RFI #: 192
 Date: 9/25/2012
 Job: EB-02 Keller Springs Lofts
 Phone: 877-777-5115

Subject: Steps at stair #8

RFI #: 196
 Date: 10/12/2012
 Job: EB-02 Keller Springs Lofts
 Phone: 877-777-5115

Subject: Hardi Panel at Meter Center Location

Drawing: 3/4.1, 2/4.4, 1/4.4, 3.1E, 1.C
 Cost Impact: None

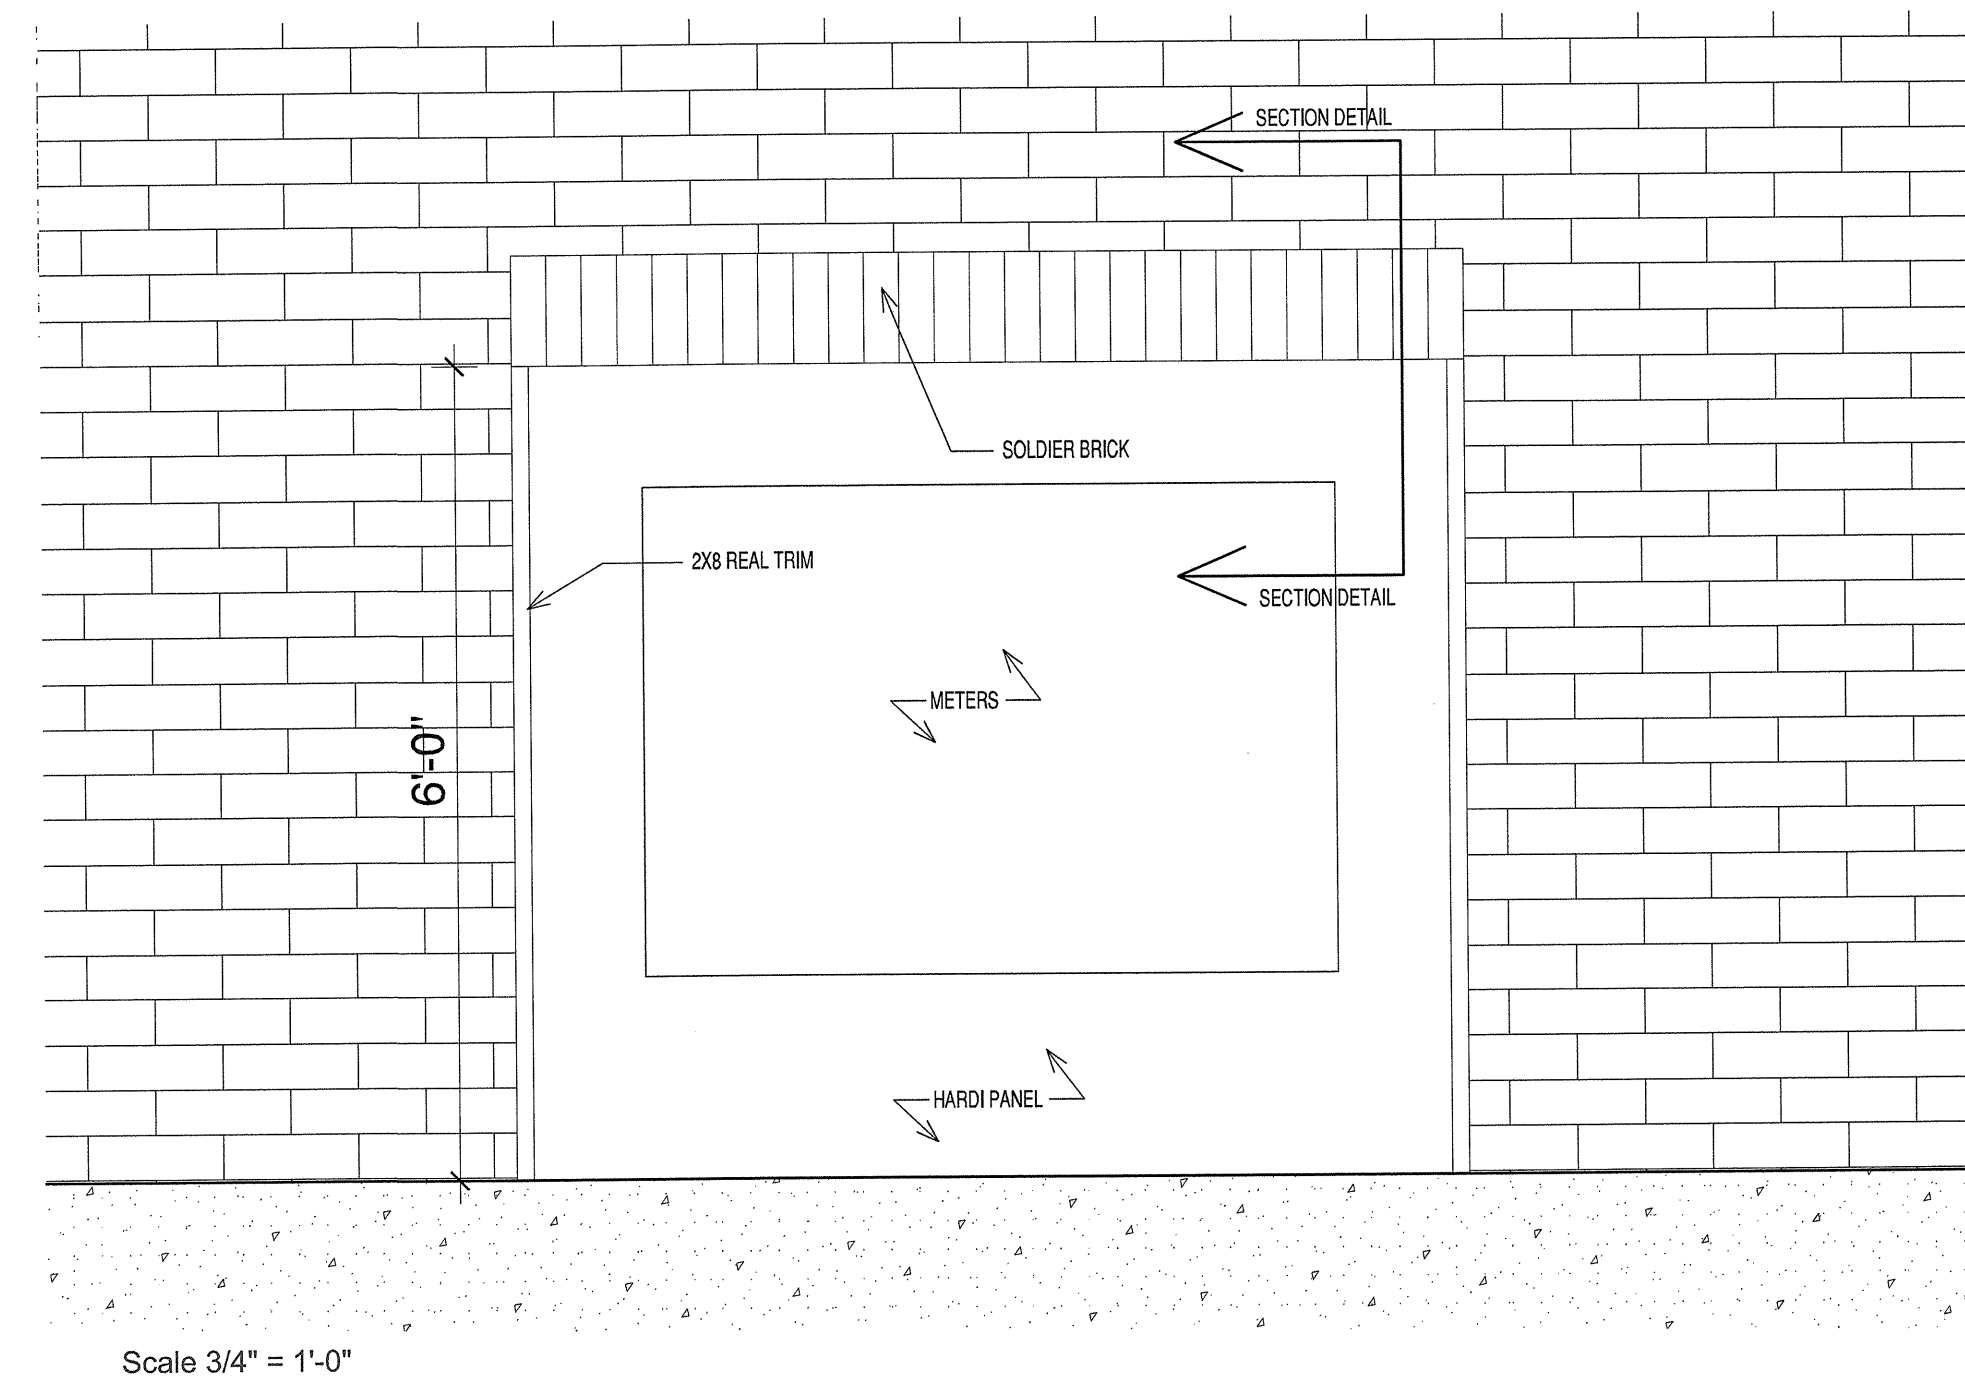
Request: Date Required: 10/2/2012
 There is a conflict on the Architectural plans at stair #8. On 3/4.1, 2/4.4, and 1/4.4 the building elevation shows steps leading into stair #8 at the exterior with an elevation of 64'1" - 7'3/4". On the Architectural and Structural foundation plans there are no steps and we agreed previously to make the elevation at the storefront 638.875 or 638' - 10 1/2". Please confirm that we are eliminating the steps and the foundation and landscape plans correct.

Response:
 BGO Response: The steps shown on the elevations in front of Stair #8 should not be there. If the landscape drawings added the storefront by stair #8, then it would be correct.

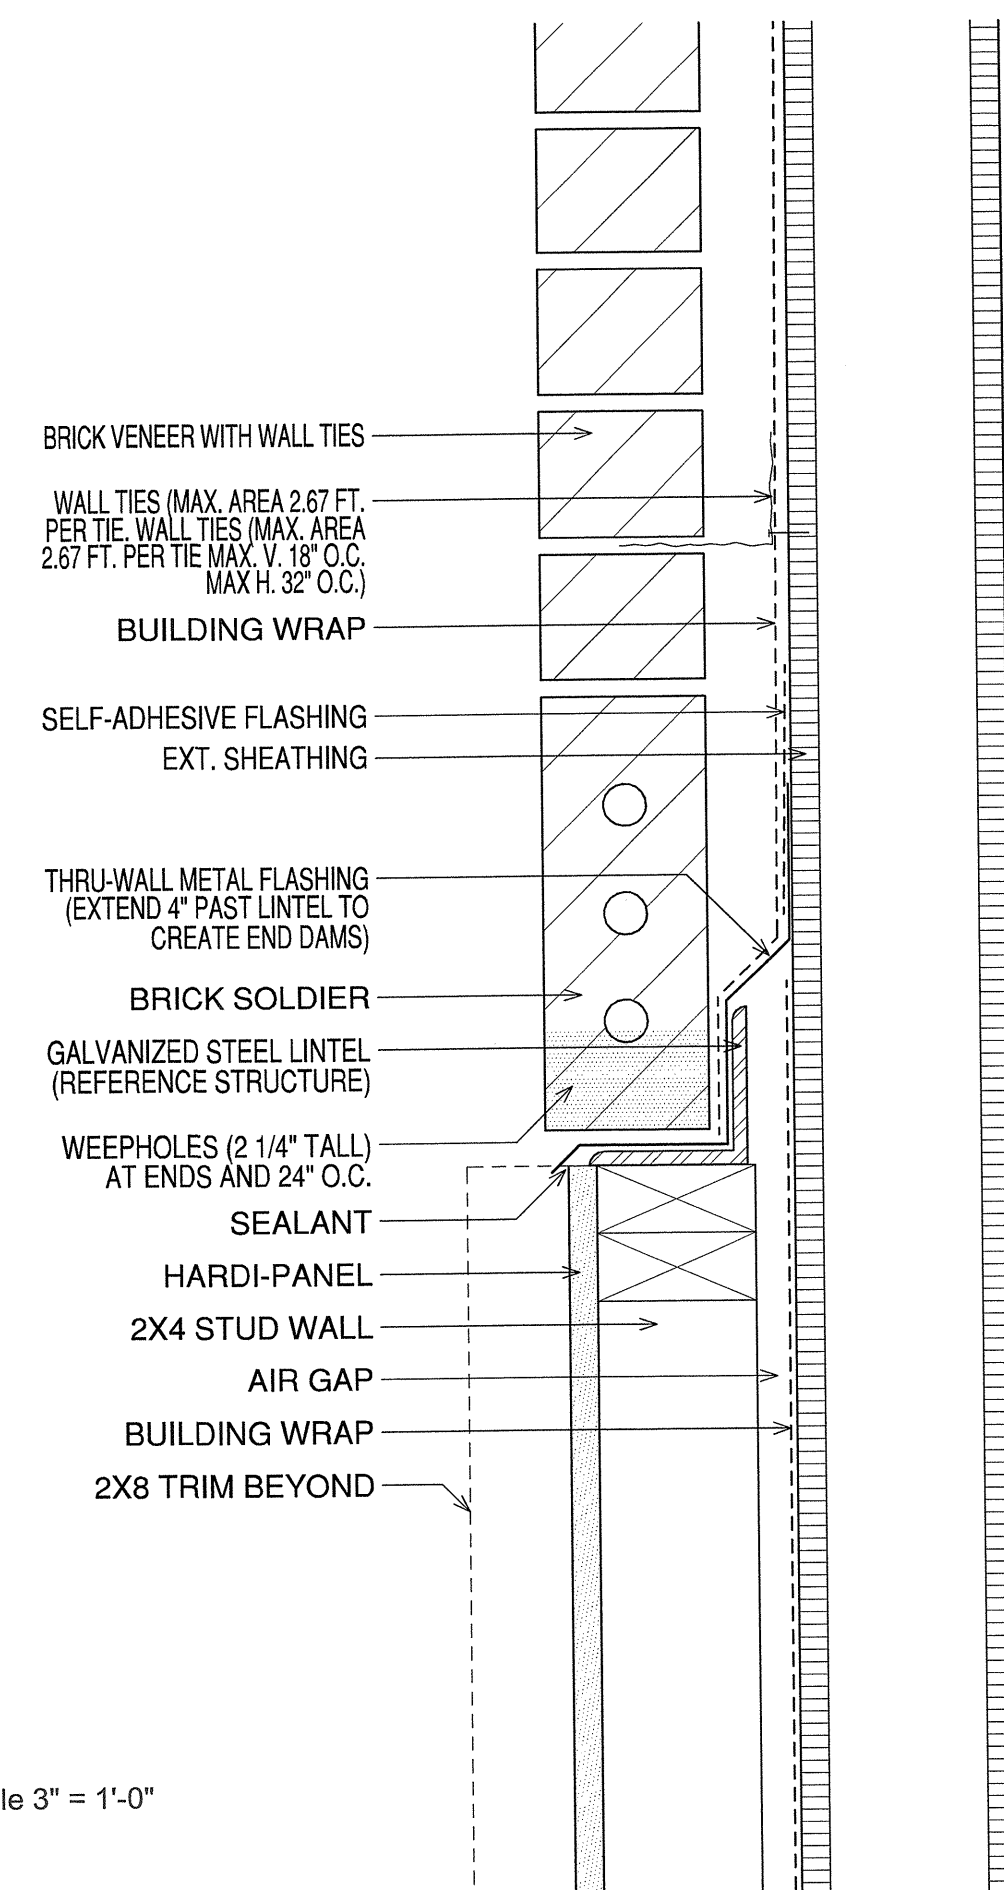
Request: Date Required: 10/18/2012
 As previously discussed, Embrey would like a working sketch for creating a Hardi panel wall at all Meter Center locations to insure proper fastening and waterproofing. Please see attachments.

Response: See next 2 sheets of this PDF.
